PROPOSAL FOR MODIFICATIONS TO WORDING IN SECTION 4.2.1.1, AND FIGURE 4-7

Alternative Section D - D (Flat Contacts)

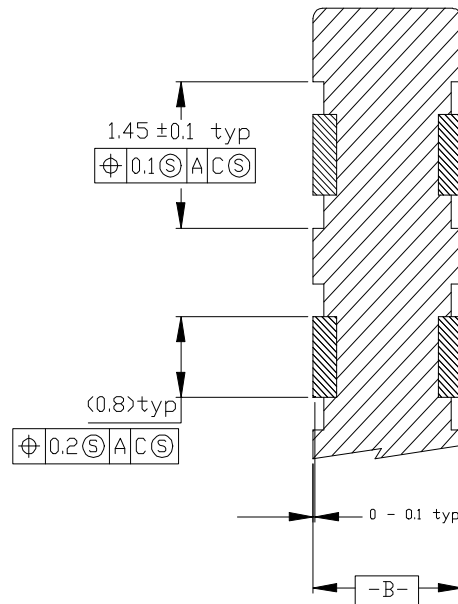
It is likely that there will be several variations of sockets to meet differing mounting orientation requirements, panel/bulkhead mounting, and/or assembly techniques. The socket contacts may also vary, as shown in Alternative Section D-D of Figure 4-7, to allow for performance enhancement of the connector, while remaining plug compatible. Regardless of these variations, the connectors must adhere to the performance criteria defined in 4.2.1.3. The holes and patterns (footprint) for the mounting of some of the possible versions of connectors to the printed circuit board (PCB) are recommended in annex I.

The following figure would be added to figure 4-7 of IEEE1394-1995.
